Access Compliance Report

Public Rights-of-Way

(Curb Ramps)

Intersection ID: 13959	Main Street: CLEVELAND_AV	Cross Street: E_PARK_AV	Location: S
ADA ID: E43F9929B6FB	Ramp Type: PerpDiag	Initial Pass/Fail: Pass	Overall Compliance: No
		Severity Score: 27.5

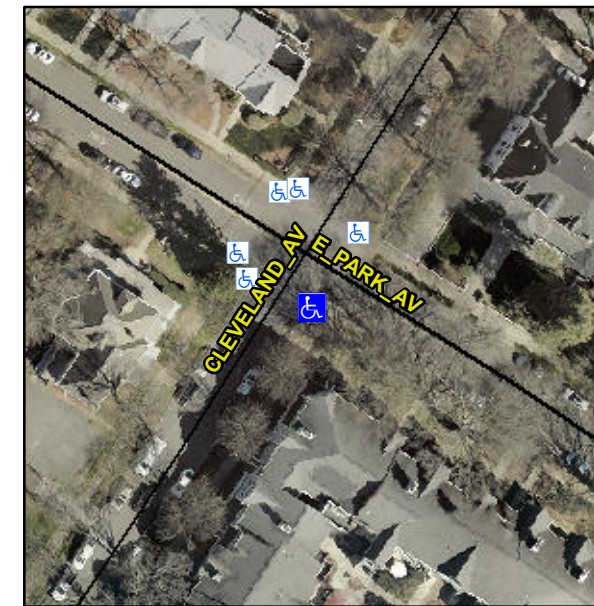
R304.2.1, R304.2.2-Perp, R304.3.2-Para, R304.5.3, R305.1.4, R305.2, R302.7, R302.7.2

Remove & Replace Curb Ramp With Two New Directional Ramps or Equivalent. Grind Gutter Lip.
